**Package Title: Construction of Tunnelling Works including Testing and Commissioning for Double Line High Speed Railway using Tunnel Boring Machine (TBM) and New Austrian Tunnelling Method (NATM) between Mumbai Underground Station at Bandra-Kurla Complex (MAHSR Km. 0.773) and Shilphata (MAHSR Km. 21.150) in the State of Maharashtra for the Project for Construction of Mumbai-Ahmedabad High Speed Rail.**

**Package No: MAHSR-C-2**

**Response to Bid Queries - 1**

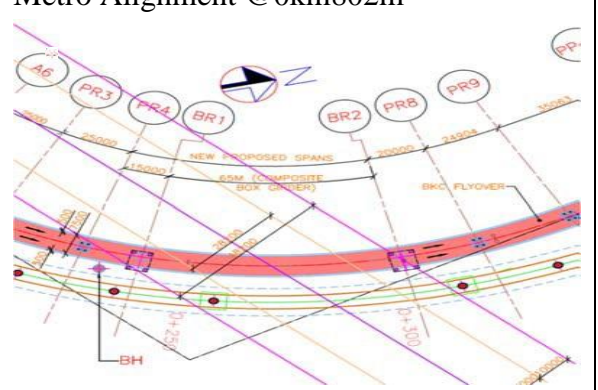
6.	Part 2 Section VI-1 General Specifications Division 04000 Works Administration	Page 95 of 100	Appendix 04000-1 Schedule of Interface, Coordination and Cooperation with Other Parties Chapter 3 Interface Table for Design, Supply and Installation Items Table 4, Item No. 3	It is stipulated that “Table 4: Interface Table between C-2 and C-3 and P-1(A)	Necessary correction will be issued in subsequent Addendum.

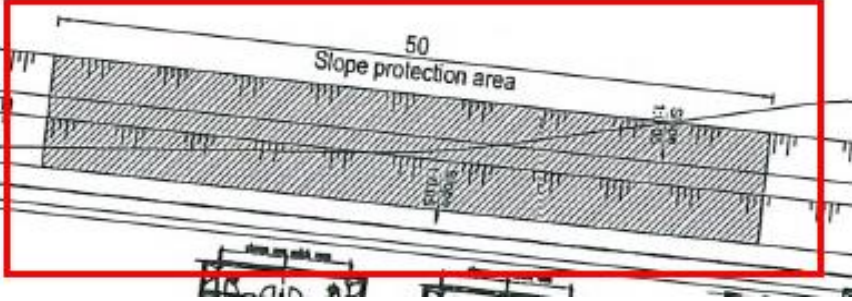
118.	Part 3; Section VIII, Particular Condition (PC), Part A- Contract Data	Sub-Clause 2.1, Time for access to, and possession of all parts of, the Site	Right of Access to the Site/Project Location & Layout	Bidder requests the Employer to kindly share i) .kmz file of the Project layout ii) Status of Land Acquisition iii) Clearances for Environment, NGT, Forest, Wildlife, Statutory	The Condition(s) of the Bidding Documents shall remain unaltered.

No	Part & Section reference	Page no / Clause No.	Provisions as Per-Bidding Documents	Bidder Query	Employer's Reply
				Compliances, etc. iv) Detailed Project Report

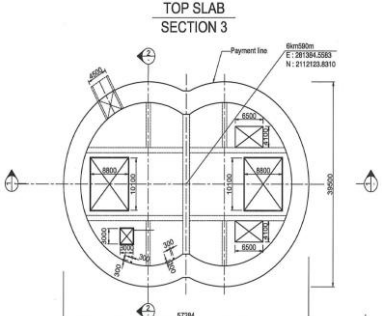
140.	Part 2 Section VI-1 (GS) Division 01000	Cl. 10 Mandatory Approvals from the concerned Authorities Page 11 of 11	Mandatory Clearances / Approvals / Sanctions	<p>The Works may require mandatory clearance / approval / sanction from the concerned Railway Authorities/ Civil Authorities before they can be undertaken by the Contractor. The responsibility of obtaining necessary sanction / clearance of the concerned authorities before undertaking the work rests with the Contractor. Please provide the list of mandatory clearances / approvals / sanctions required before the undertaking by the Contractor.</p>	The condition(s) of Bidding Documents shall remain unaltered.

No	Part & Section reference	Page no / Clause No.	Provisions as Per-Bidding Documents	Bidder Query	Employer's Reply
141.	Part 2 Section VI-1 (GS) Division 06040	Cl.8 Borrow Areas and Quarries Page 23 of 51	Clause 8 of Division 06040	<p>It is stipulated that "1) It shall be the responsibility of the Contractor to arrange for borrow areas (for fill material) and quarry sites (for ballast, aggregate and rock material) using his own resources. The Contractor shall be responsible for carrying out his own investigations to verify the availability, sufficiency, quality and quantity of materials from such sources. The Contractor may also arrange any additional borrow areas and quarry sites as required by him, all at his own discretion. No claim whatsoever shall be entertained by the Employer in this regard. 5) Borrow areas, quarry sites and the installation of rock crushers shall not be permitted within the ROW."</p> <p>Clause 8 of Division 06040 "Borrow Areas and Quarries" stipulates that they are not allowed inside ROW. Clause 8 "Stockpile Areas" stipulates that stockpiles are allowed inside ROW. Please provide further clarifications on the difference</p>	The condition(s) of Bidding Documents shall remain unaltered.

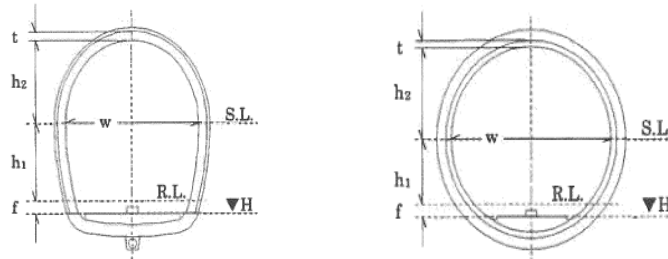
154.	Part 2 Section VI-2 Technical Specifications	Clause 219 Page 179 of 199	Metaled Access Roads	It is stipulated that "Measurement for payment of this item shall be in sqm of area of the black top surface of metaled access road as shown on the Drawings or established at the Site by the Engineer. The payment for the item shall be made at Unit Rate per sqm, entered in the Priced Bill of Quantities. This item includes cost of all the items for construction of road complete in all respects as shown in the Drawings."  Please clarify the definition of "the black top surface".	Refer Addendum No. 2 Item No. 1 and Addendum No 3 Item No. 90.

No	Part & Section reference	Page no / Clause No.	Provisions as Per-Bidding Documents	Bidder Query	Employer's Reply
155.	Part 2 Section VI-2 Technical Specifications	Clause 301 Page 179 of 199	Excavation of Shaft	<p>It is stipulated that "Measurement for payment for excavation in all kinds of strata will be of the in-situ volume of material excavated from the levels recorded prior to any excavation work and the lines and grades (up to the pay line) shown on the Drawings or established at the Site by the Engineer. The bottom level of excavation shall be taken as the bottom of levelling concrete as shown on the Drawings. The area of excavation shall be taken as per the payment line shown in the Drawings. No payment shall be made for excavation carried out beyond payment line." Please confirm "the payment line" shown in the drawings for construction of Shaft are payment limit for excavation only. Typical sketch below is extracted from dwg no. TD-JIC-IC1-TDC-B01-UST-NTU-15010000</p> 	Refer Addendum No. 2 Item No. 1

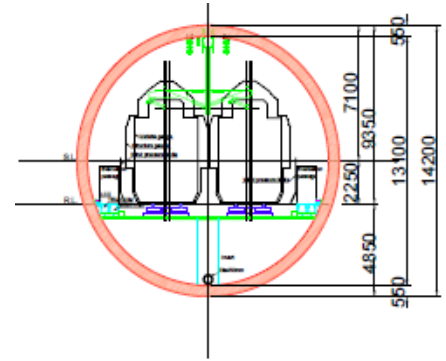
166.	Section VI-2 Specification (Technical Specification)	Cl.4.10 Page 41 of 199	Tunnel Survey	<p>Bidding Documents Item (3) Wriggle survey stipulates "Wriggle survey shall be carried out after the breakthrough of TBMs to check the intrados of built tunnel with respect to design tunnel alignment. Based on the report of wriggle survey the Contractor shall propose final horizontal and vertical alignment of the tunnel ensuring no infringement to SOD to obtain approval from the Engineer. After this, laying of backfilling concrete and track bed concrete shall be undertaken."</p> <p>In terms of back fill concrete, can the Contractor place back fill concrete before breakthrough of TBMs by assuring the given tolerance in order to shorten the construction period?</p>	Refer Addendum no 3 Item no 83

No	Part & Section reference	Page no / Clause No.	Provisions as Per-Bidding Documents	Bidder Query	Employer's Reply
167.	Section VI-2 Specification (Technical Specification)	CL.4.21 Page 55 of 199	Breakthrough of TBM-1 and its removal	<p>It is stipulated that "TBM-1 shall breakthrough in shaft 1 (to be constructed by C-1 Contractor). The soft eye in shaft-1 shall be provided by the C-1 Contractor as per the requirement of the C-2 Contractor. All other preparatory works for receiving and removal of TBM-1 shall be carried out by the C-2 Contractor. The Contractor shall submit method statement for carrying out preparatory works for receiving the TBM and for removal of the same to obtain approval from the Engineer."</p> <p>Please provide</p> <p>a) structure and arrangement of reinforcement drawing for Shaft-1 and</p> <p>b) Construction schedule for Shaft-1 and</p> <p>c) related information such as milestone and hand over date to study what kinds of preparatory works may be necessary.</p> <p>We believe that the such design information will be issued as the Addendum of the Bidding Documents soon.</p>	(a) & (b) the arrangement of reinforcement for shaft 1 and construction schedule will be provided after award of Contract.(c) refer Addendum no 3 Item no 15 and 16.

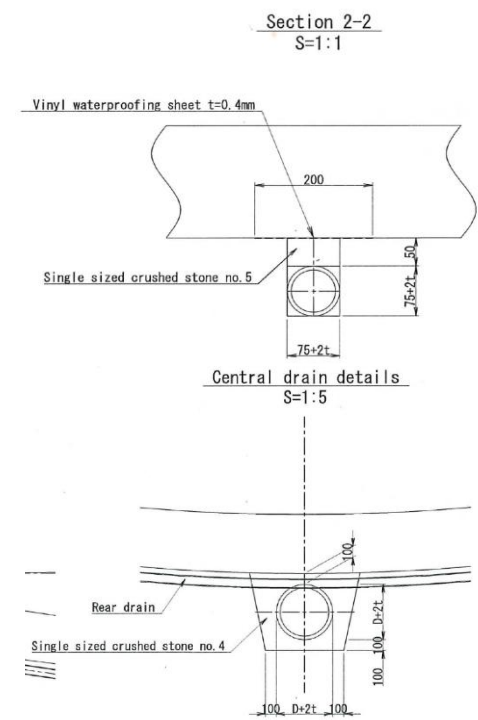
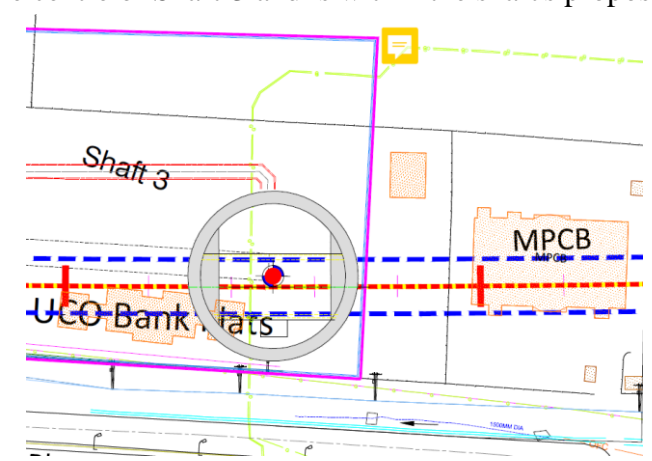
200.	Part 1 Section IV Bidding Forms Bill of Quantities <b>Item 407</b> & Part 2 Section VI-3 Drawings <b>5. COMMON, TD-JIC-IC1-TDC-B01-UST-NTU-00340000 and 00390000</b>	Pages 69 of 159  Pages 11 & 16 of 16	Rebar Corrosion Monitoring System at NATM Tunnel	<p>The rebar corrosion monitoring system at the TBM Tunnel is paid under Bill No. 407 which stipulates “Supplying and installing reinforcement steel bar corrosion monitoring system (Anode ladder type) in RC segments and providing 3 Nos. (Total) hand measuring instruments in accordance with the Specification and the Drawings” and the Quantity is 15 nos. as per Drawing 00340000.</p> <p>However, there is no Bill No. for the similar rebar corrosion monitoring system at the NATM Tunnel and whose quantity is 1 No. as per Drawing 00340000.</p> <p>Please confirm where to price for this item at the NATM Tunnel.</p>	This will be issued in an Addendum.

No	Part & Section reference	Page no / Clause No.	Provisions as Per-Bidding Documents	Bidder Query	Employer's Reply
201.	Section IV Bidding Forms Bills of Quantity Items 307, 324, 506 (b), and 513 (b) Section VI-4 Reference Information Att. 08 Information Drawings_20190409	Pages 38, 53, 78, 86 of 159  Page 22 of 26	Undersea Tunnel “List of Information Drawings – Main Tunnel (NATM)” dwg No. TD-JIC-IC1-TDC-B01-UST-NTU-41140000	<p>Under the Bills of Quantity, it is stipulated that “<i>Excavation/removal of unsuitable material (below subgrade) and filling by M-20 grade concrete in accordance with the Specification and the Drawings subject to the approval of the Engineer.</i>”</p> <p>While the Bills of Quantity explains that excavation/removal of unsuitable material (below subgrade) shall follow the Specifications and drawings, we cannot find any relevant specifications and/or drawings with the exception of the drawing referred herein titled “Replacement of Unsuitable Material”.</p> <p>We would like to query the followings;</p> <ol style="list-style-type: none"> <li>1. The drawing is located in Section VI-4, which is basically provided “<i>for reference purpose only</i>”. Please confirm the intention of this drawing.</li> <li>2. The referred drawing states “<i>Replacement of unsuitable material by M10 grade concrete</i>”. The backfill material is different from M-20 as stipulated in various parts of the Bills of Quantity. Please clarify which grade of concrete shall apply.</li> <li>3. The drawing does not show the depth of replacement by M10, but from the scale, the quantity seems to be very different from the pertinent Bill of Quantity Item 506(b) which shows 200 cubic metres. Please clarify</li> </ol>	<p>This will be issued in an Addendum.</p>
